| Number | TRIM | Support/Not Support | Comments or Concerns | Response |

DRAFT LOCAL PLANNING POLICY NO. 2 WEARNE REDEVELOPMENT LOT 87 (8) WARTON STREET, COTTESLOE

Draft Local Planning Policy No. 2 Wearne Redevelopment, Lot 87 (8) Warton Street Cottesloe

DRAFT LOCAL PLANNING POLICY WEARNE REDEVELOPMENT NOV 2018
LOT 87 (8) WARTON ROAD, COTTESLOE WA 6011

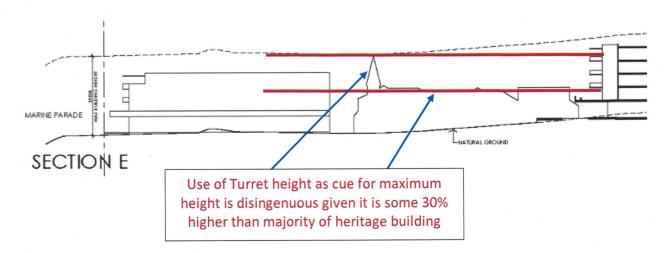
- Section 6.4.8 of Draft Policy No. 2 suggests taking height precedent from the adjoining WA Deaf School is highly misleading and biased as it does not adequately consider the relative topography and significant reduction in ground level as you move west towards Marine Parade. As a result by maintaining building height at the same level as the WA Deaf School you are effectively increasing the building height in relation to the ground as you move west along Warton Street (see figure below from Draft Master Plan).

• Similarly, under Section 6.4.8 taking height cues from the existing Heritage building is also misleading and disingenuous as it takes the maximum height of the pointed turret which is some 30% higher than the rest of the existing heritage building. This is an unreasonable proposal given the maximum height allowance as determined by the small turret section is being used to justify the maximum height of a significant mass of square building at same height.

| Number | TRIM | Support/Not Support | Comments or Concerns | Response |
|--------|--|---------------------|---|---|
| | | | Raises concerns over the exit and entry for | The height cues taken from the Waide site are |
| | | | parking located on Warton Street (increases | done to show the overall impact the |
| | | | from 29 vehicle movement level current | development would have, it was not intended to |
| | | | experienced) | mislead anyone. |

BUILDING SETBACKS

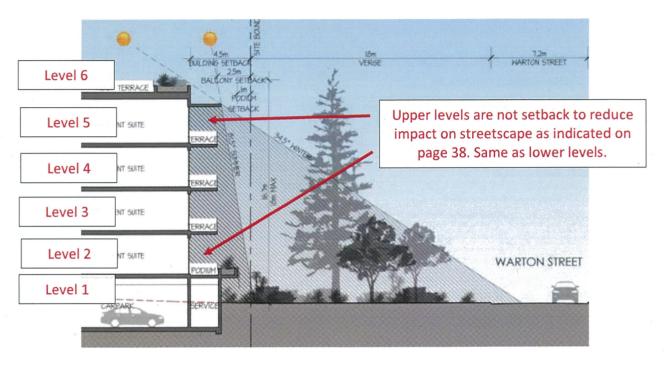
• Despite claims on page 38 of the Draft Master Plan stating that "the upper levels will be setback and designed not to dominate the adjacent streetscape" all indicative drawings of the 5+1 (6) storey buildings on Warton Street show identical setbacks for both upper and lower levels. This is a violation that appears to be confirmed in Section 6.4.3 of Draft Policy No. 2 as all upper storeys expected to be articulated with change of material, colour and variation to break down the perception of mass (underlined for emphasis). Note these measures only address the 'perception' of mass and do not deal directly with the reality of the flawed building design in relation to mass.

- Section 6.3.1 specifies the setbacks for the basement. Yet again I consider setbacks of NIL for Gibney and Warton Streets basement levels with protrusions up to 3 metres (essentially the height of a single storey residential dwelling) to be in direct contravention of the stated Objectives in Section 2 of Draft Policy No. 2 and LSPS3.

- Similarly, Sections 6.3.2 and 6.3.3 that specify setbacks for Ground /podium levels and Upper floors which include NIL Balcony setbacks, podium setbacks of only 1 metre and wall setbacks of only 2 metres is again contrary to the stated Objectives of Draft Policy No. 2.

| Number | TRIM | Support/Not Support | Comments or Concerns | Response |
|--------|--|---------------------|---|---|
| | | | Concerns over tree being removed (on | The upper floors on Warton Street are set back |
| | on section of the sec | | Warton Street) | from the boundary. Setback in this sense applies |
| | | | Concerns over works starting early | to the distance from the boundary, not the lower |
| | | | | floors. As stated above, the diagram in the Policy |
| | | | | relates to the property boundary, a detailed |
| | - | | | diagram showing the setback from the road is |
| | | | | shown on page 52 of the Master Plan. |
